POINT VISTA SUBDIVISION
MASTER DEVELOPMENT PLAN
M.D.P. # 025-07
DATE: 6/22/2007

Department of Development Services

Re: **Point Vista Subdivision** **MDP # 025-07**

The City Staff Development Review Committee has reviewed the **Point Vista Subdivision** Development Plan, **MDP # 025-07**. Please find enclosed a signed copy for your files. Your plan was approved for acceptance, however, please note the following conditions:

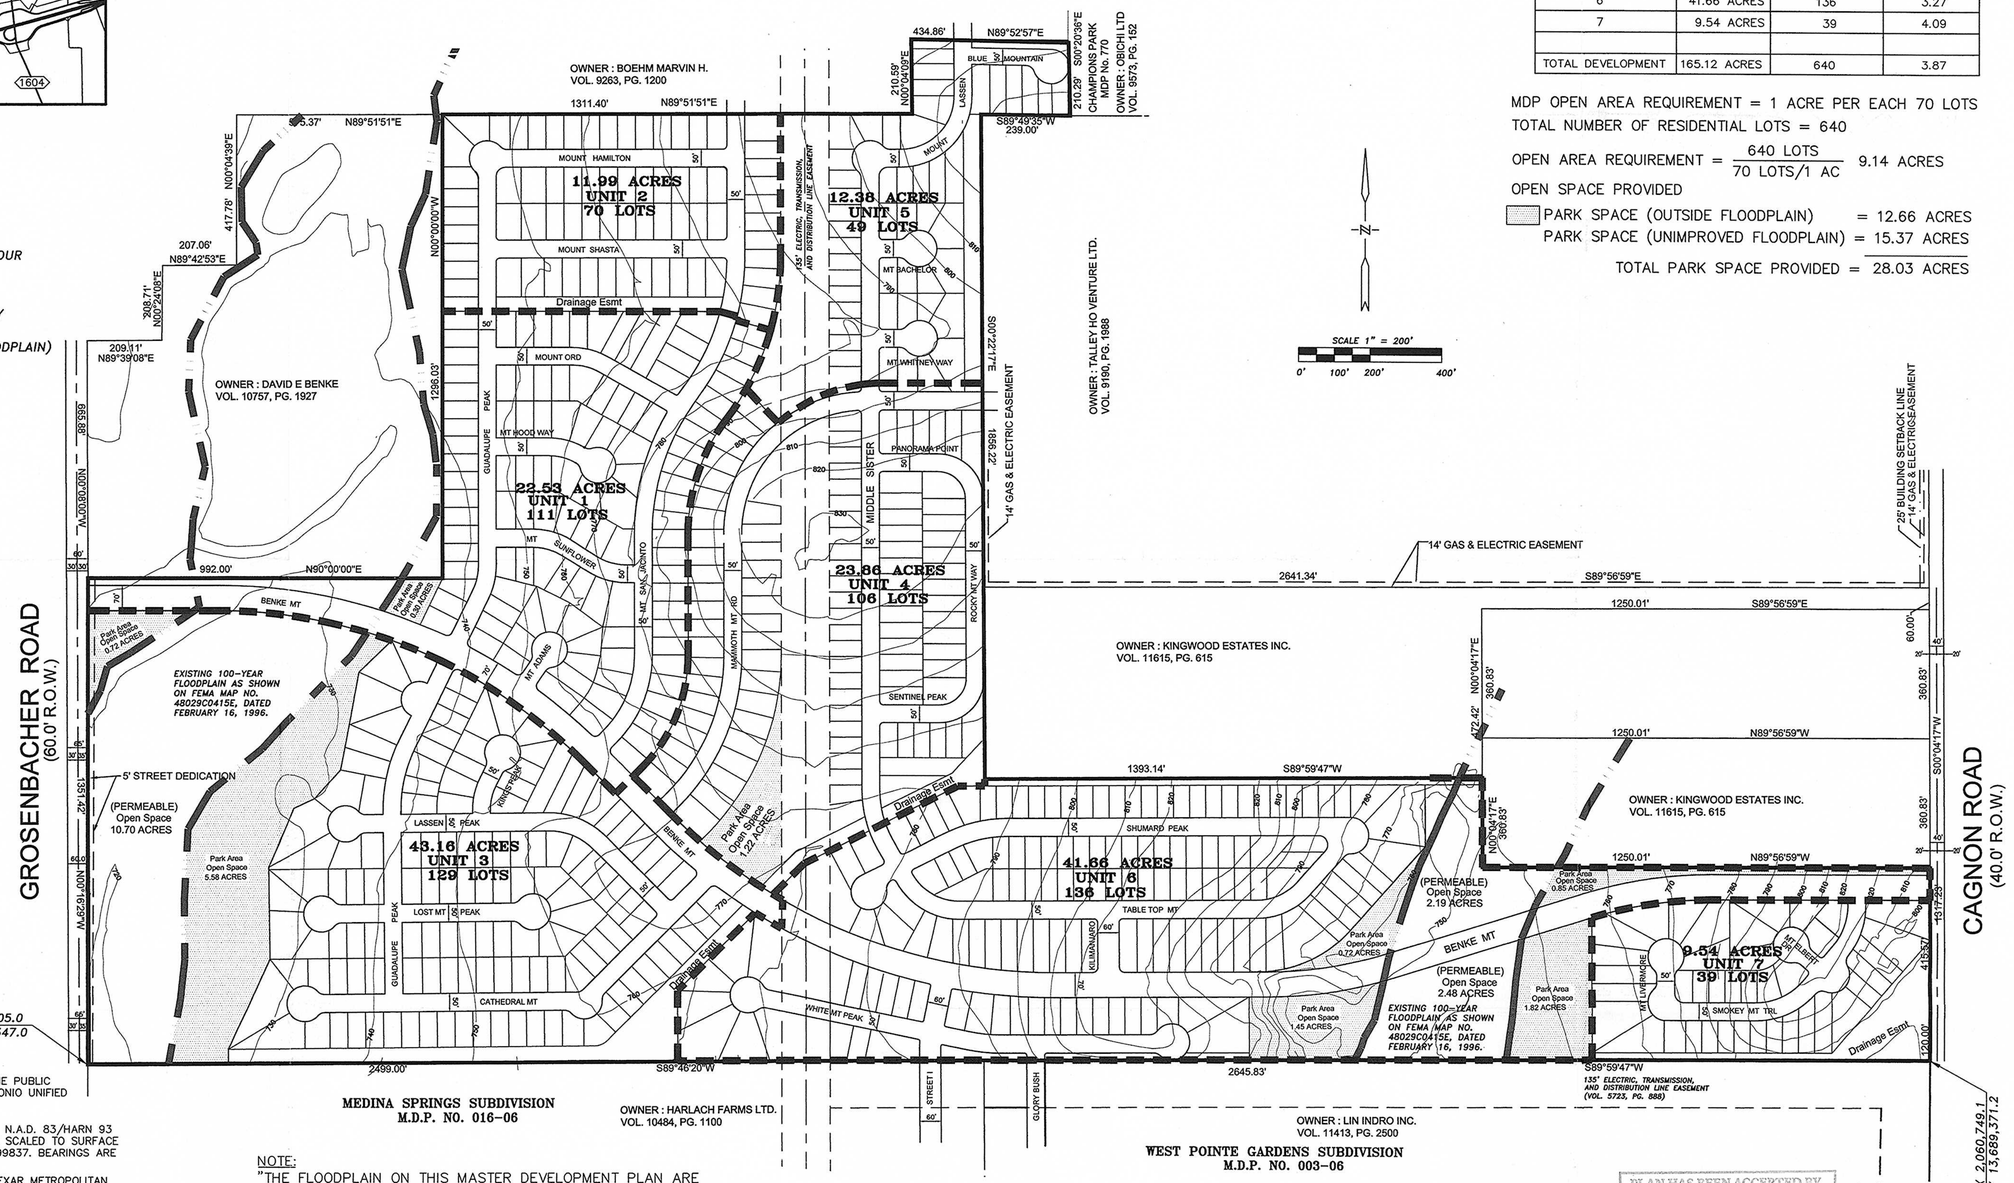
In consideration of public safety and convenience, excessive grades by reason of topography should be avoided in street layouts and arrangements. Any access and R.O.W. issues along state facilities will need to be resolved with the **Texas Department of Transportation (TXDOT)**. For information about these requirements you can contact TXDOT at (210) 615-5814.

- All roadways shall follow Table 506-7, Functional Classification System Description and shall comply with UDC §35-502(a) (9).

- All access roadways shall provide clear sight distance on all existing and proposed roadways in order to provide adequate obstruction free viewing distances for approaching traffic.

- The developer shall be responsible for providing a right-turn deceleration lane at the two proposed entrances, with storage length and bay taper per TXDOT design standards as it relates to the submitted TIA traffic counts, (Uniform Development Code (UDC) - §35-502 (a)(7), subsection C.

- Dedicate 70-feet of ROW and construct a 4-lane undivided roadway.

- Sidewalks along all interior and exterior roadways are to be installed in accordance with UDC §35-506(q).

- Developer shall dedicate 5 feet along Grosenbacher.

- Streetscape standards per UDC §35-512 - The new ROW on Benke Mt. (collector) will require streetscaping as well (we recommend preservation of existing trees where available and possible).

- The parkland provided shall be shown as "Park" or "Open Space" on a plat; UDC §35-503(e) *Designation of Parkland.*
- The parkland provided is dedicated to the Home Owners Association.
- The instruments creating the Home Owners Association are provided by the second application for plat approval; UDC §35-503(e) *Designation of Parkland.*
- Parkland dedication must be platted by the second phase of residential development; UDC §35-503(f) *Development Phasing.*
- Parkland in the Floodplain Area shall comply with UDC §35-503(d) (2) *Parkland in Floodplains or Water Features.*

- A right-turn deceleration lane will be required for access to Grosenbacher Road through separate permit by Bexar County. UDC §35-502(a)(7)(D)

- Secondary access must be constructed with or prior to the approval of any plat or combination of plats exceeding 125 dwelling units as per UDC §35-506(e) (7).
